Comment A – Some hydrologic considerations for storage of High-Level nuclear waste at the Holtec Site in Lea County, New Mexico

COMMENT (286)

CITATION # 83 FR 13802

FIGURE 1 - LOCATION MAP FOR WIPP AND HOLTEC SITES

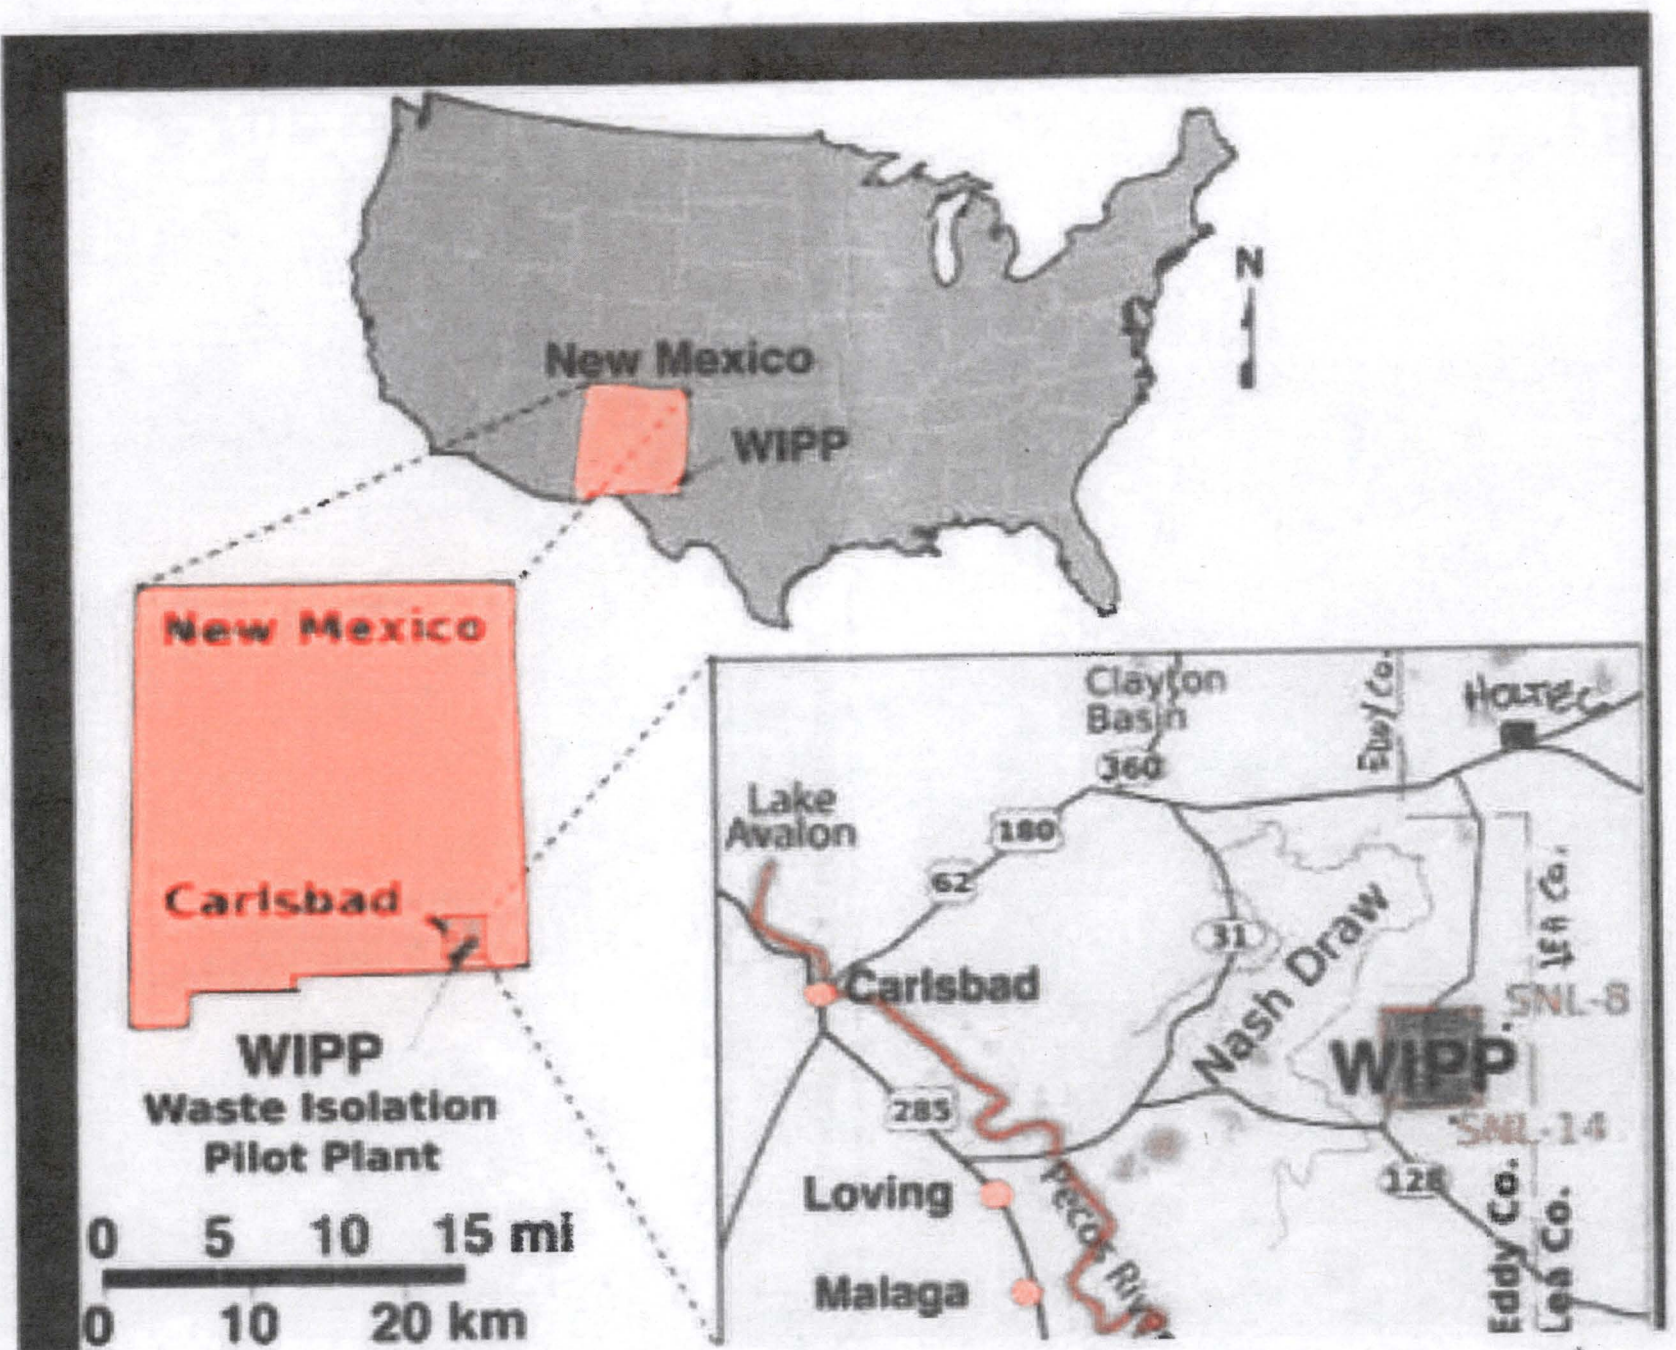
There are significant risks associated with present storage of spent, high-level (H/L) nuclear waste on the premises of the nuclear power-generating facilities that generated it, particularly when they are located in densely populated areas (this risk is significant and a solution is urgently needed). The Holtec plan to use a 1000-acre site in western Lea County, New Mexico as temporary storage for such waste in preparation for removal to a permanent storage site has merit, but neither Holtec nor the Nuclear Regulatory Commission (NRC) has guaranteed that such removal will take place. It seems feasible that after as much as 85,000 tons of H/L waste (estimated total now stored at generating-facility locations (NRC, 2009)) has been moved to this low-population, low-rainfall site and placed in shallow storage crypts, much of the national concern over the present storage problem would abate, and nothing further would be done to move the waste to secure, permanent, safe storage elsewhere (specifically, to WIPP 15 miles to the SSW – Figure 1).

FIGURE 2 - SATELLITE PHOTOGRAPH OF SALINE PLAYA LAKES IN THE VICINITY OF THE HOLTEC SITE

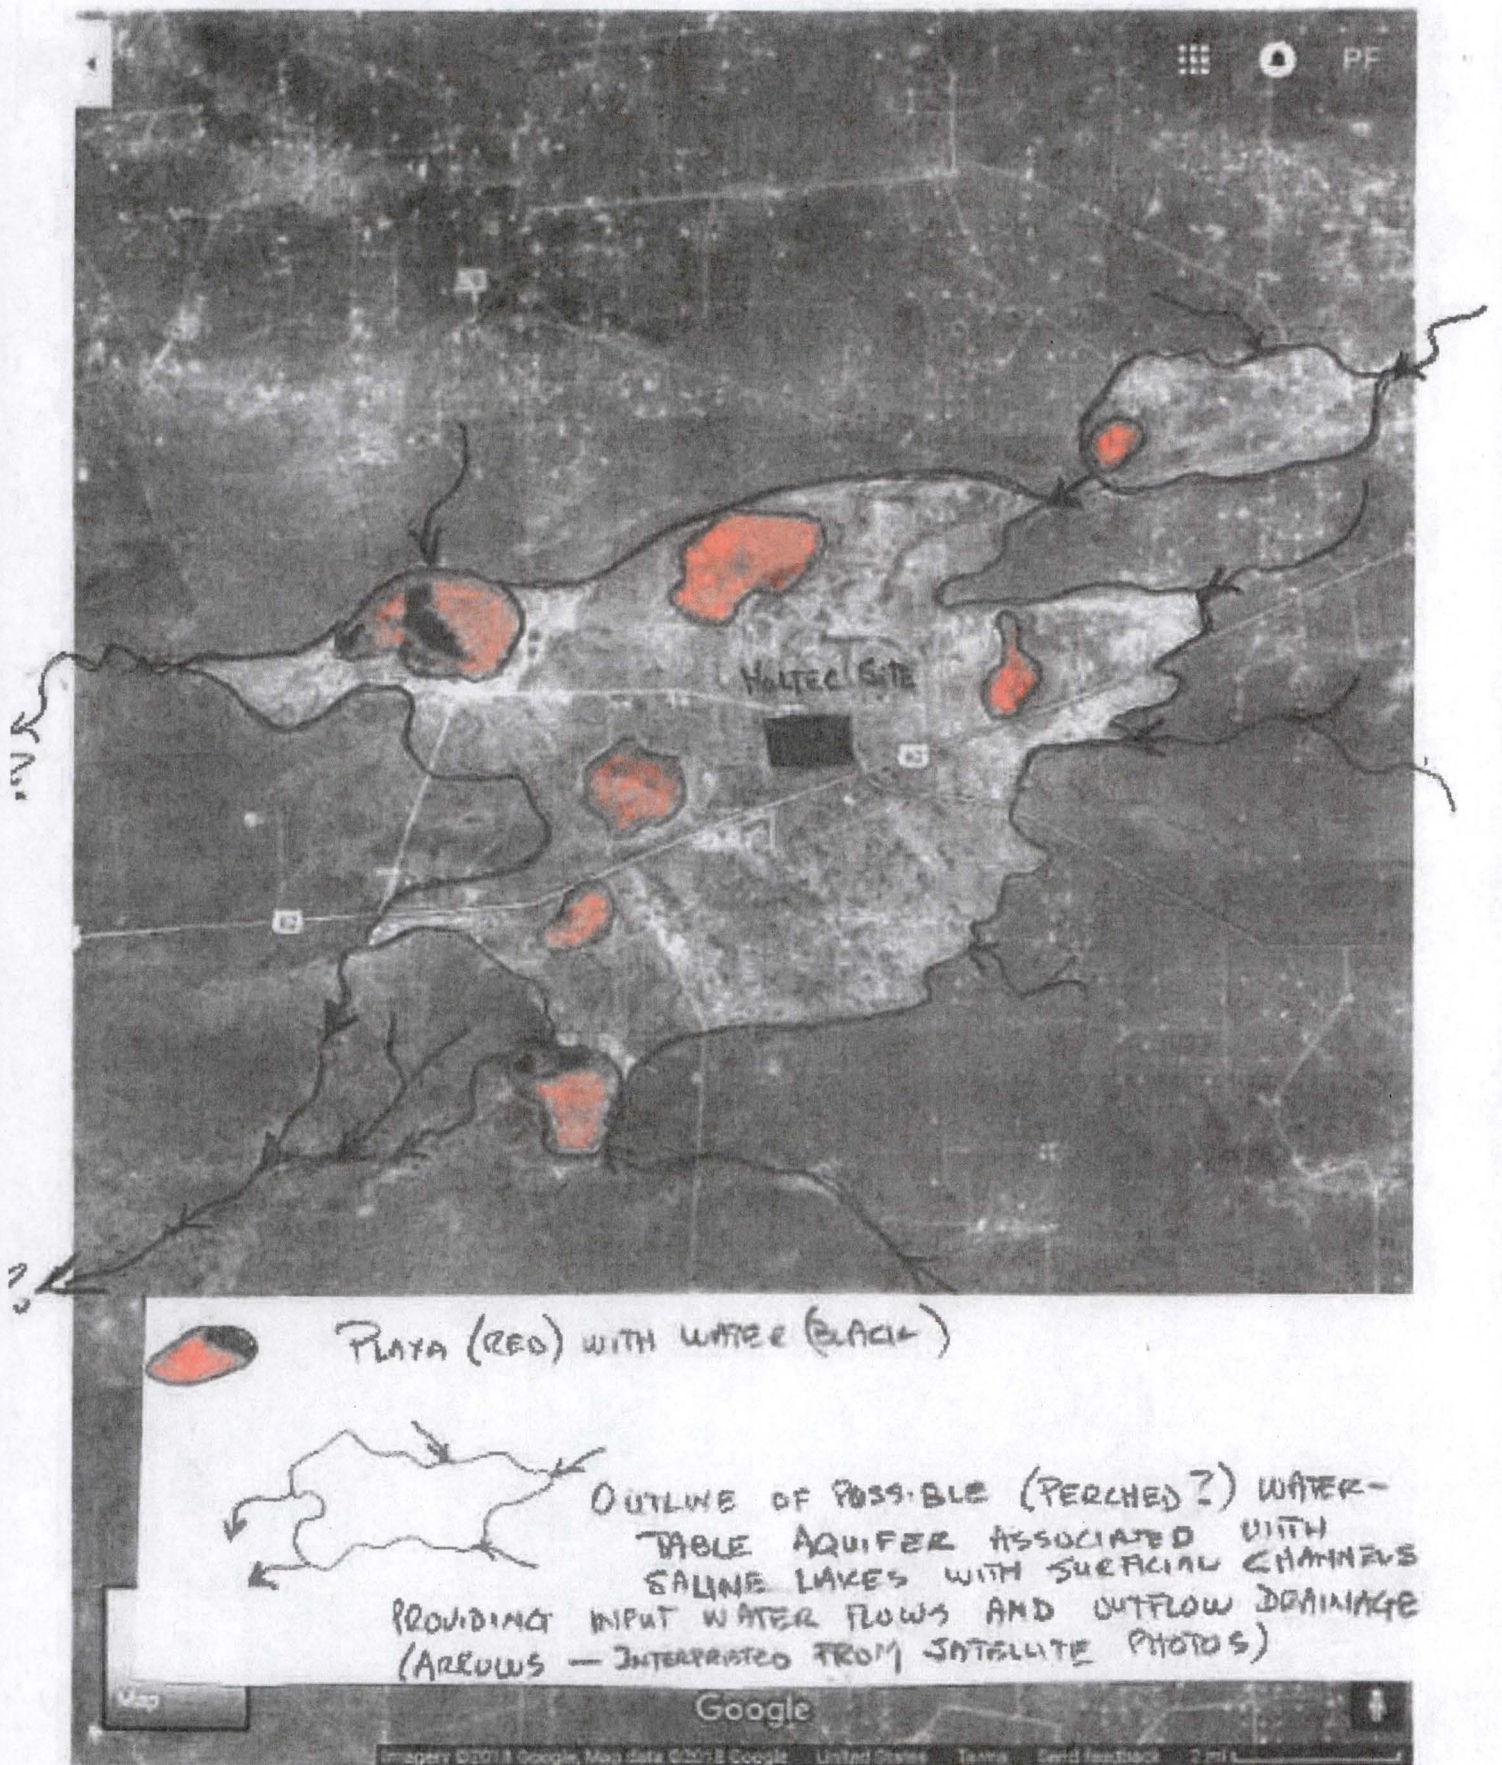
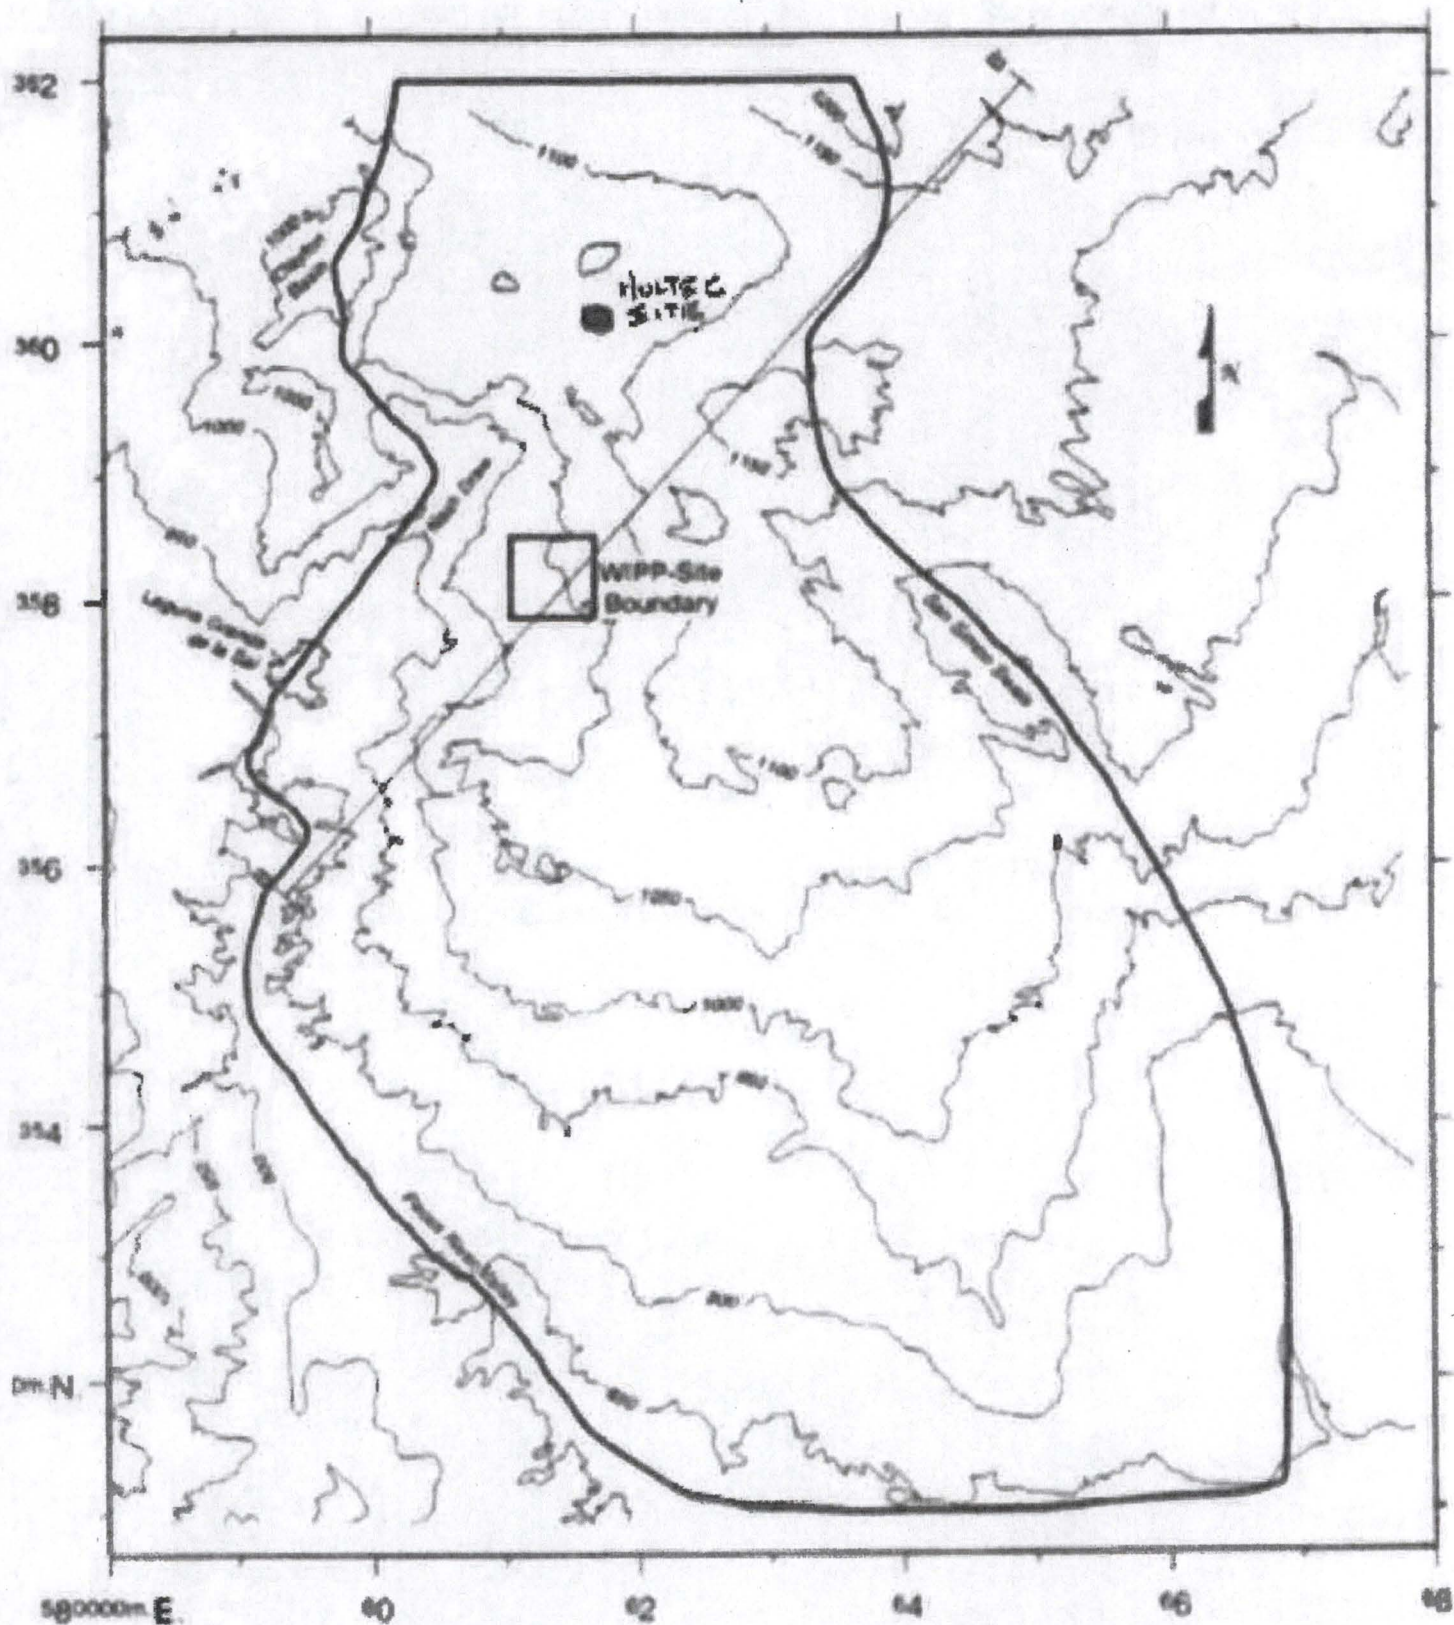
- A) **Isolated aquifer** – Figure 2 shows the location of 7 playa lakes located near HS. A survey of playas in New Mexico (Playa Lakes, Joint Venture, 2016) indicates that these lakes all contain saline water. Satellite photos were used to outline a bleached zone around these lakes comprising a sizable area underlain by unconsolidated sediment where surficial vegetation has been affected (?) by saline waters within a Playa Area, (PA - the PA and its lakes may be associated with deep dissolution of the salt section by upwelling waters from the underlying Capitan Reef aquifer (Bachman, 1987)). These same photos were also used to establish the location of surface channels outside the PA along which rain-generated runoff could carry water into the PA allowing downward infiltration to the water table but also causing run off downslope out of this area to the SW into Nash Draw (Figure 1 - the land surface around HS slopes to the SW - Figure 3, Corbet, 1996). It is probable that an isolated water-table aquifer now exists within the PA (Holtec has documented shallow water levels within unconsolidated sediment below HS and they report that depth to water was often less than 15 feet.). Over longer time frames, random rain-generated surface-water inflows into the PA accompanied by infiltration into the underlying aquifer could cause (periodic ?) downslope ground water flow through this aquifer from NE to SW. Such ground water flow could carry contaminants from any cask leakage that travelled down into such sediments out of the PA and into the Accessible Environment (AE) down gradient to the SW, including into lakes within the PA, and into shallow flow in Nash Draw. This potential problem could be rectified by moving the HS away from the PA to nearby bedrock (Triassic fine-grained outcrops with their cation exchange capacities ?), but risks associated with a new location should be fully re-evaluated.

FIGURE 4 - UPPER TRIASSIC OUTCROPS AND ESTIMATED EXTENT IN WIPP/HOLTEC AREA
(FROM BACHMAN, 1987 WITH CORRECTIONS FROM NM/Bu. Geol, 2003)

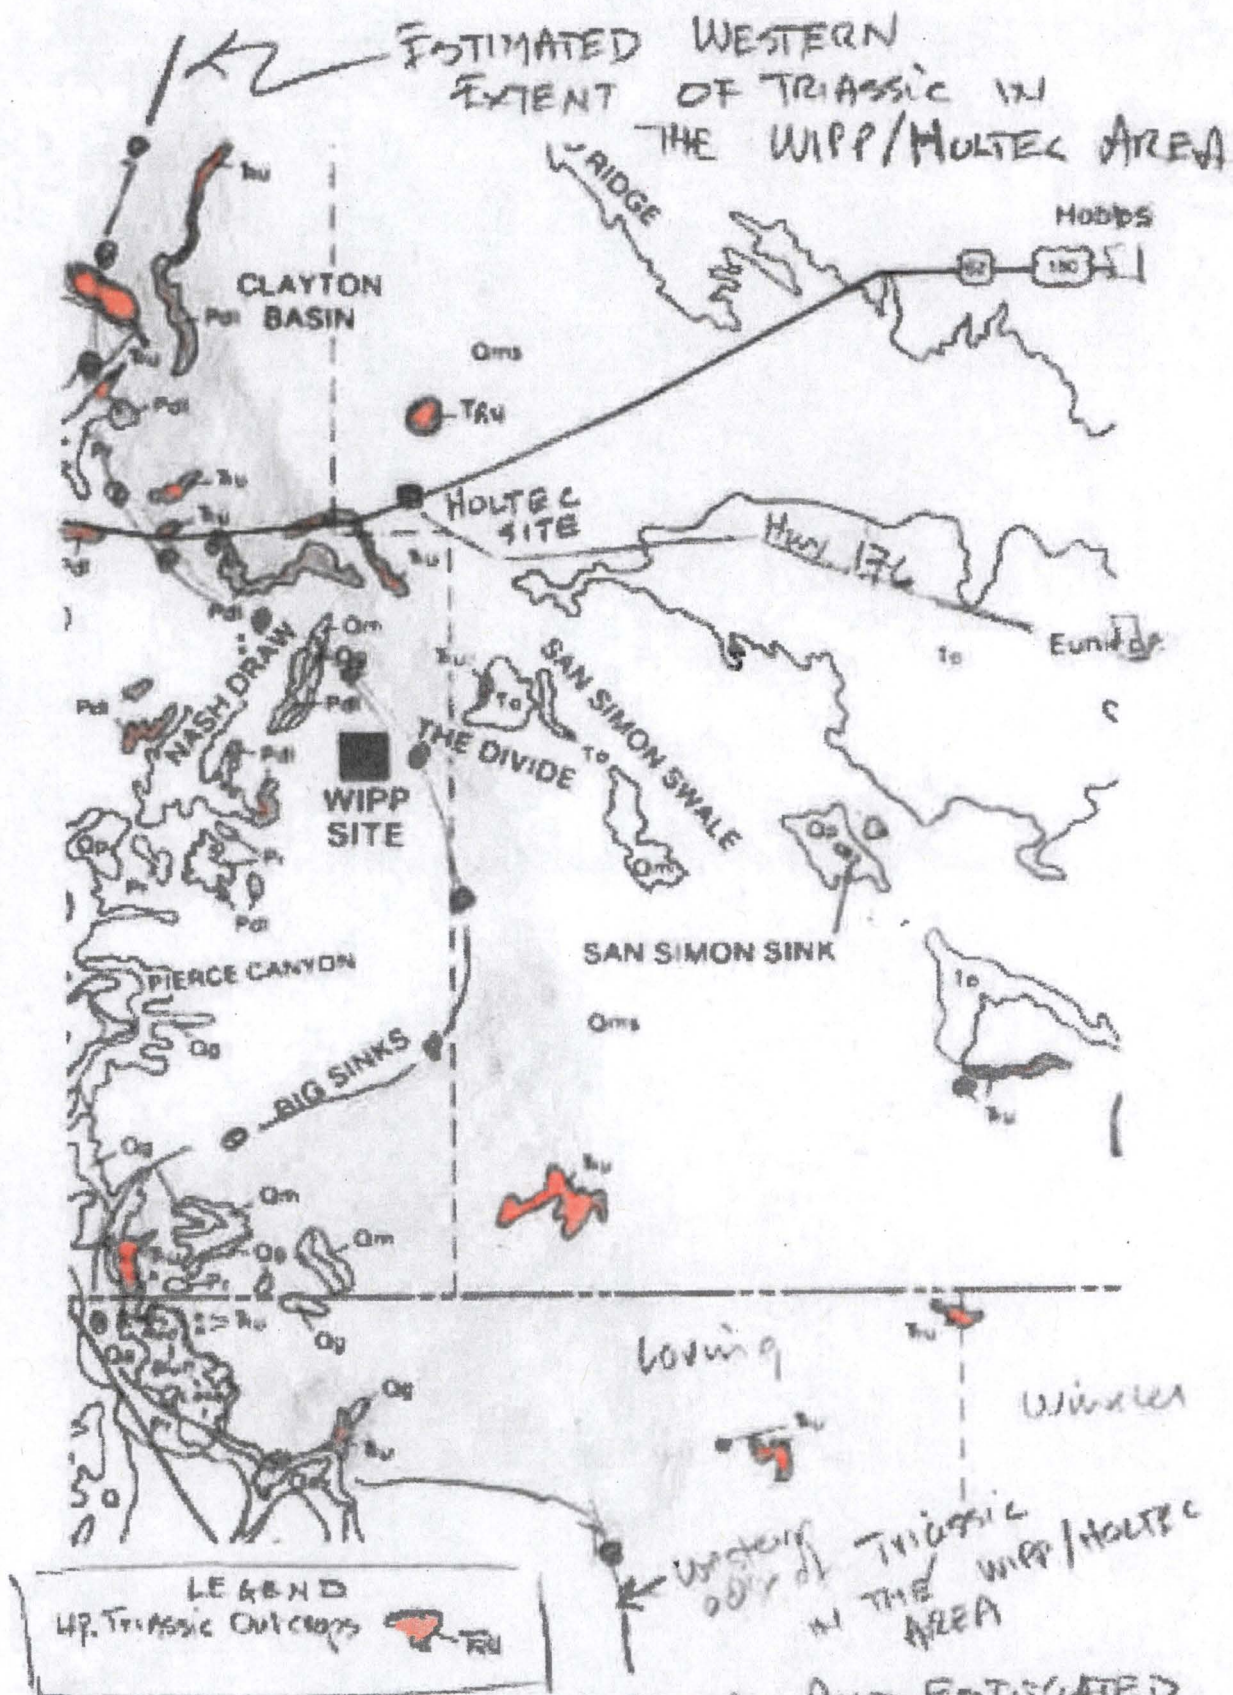
- B) – **Dockum Aquifer** - Upper Triassic outcrops are found to the immediate north, west, and south of HS (Bachman, 1987 (Figure 4) and N M Bureau of Geology, 2003, geologic maps) and it is possible that older Triassic Dockum strata (including its basal aquifer) could be found beneath the HS. If basal sand aquifers within the Dockum are present below the HS, downward
